From: GDE Change Control Board

Subject: Response to the Change Request (October 25, 2006) for the BCD RTML

Section - CCR#19

Figure 1: Approximate topology of the RTML layout and its beamline composision.

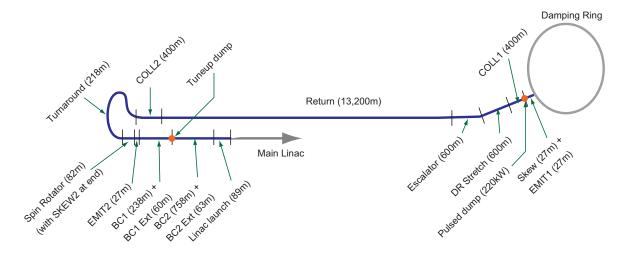
- CCB Comment 1: CCB recommends the requester to include a simple topology chart within BCD which illustrates the defined areas of sub-beamlines that are quoted in the main text of the RTML section.

- CCB recommends a small touch-up's to the proposed new text for RTML section of BCD.in
 which to introduce an easy-to-see topology diagram of the RTML beamline. A suggested new
 replacement text for the RTML section is attached in Appendix A.
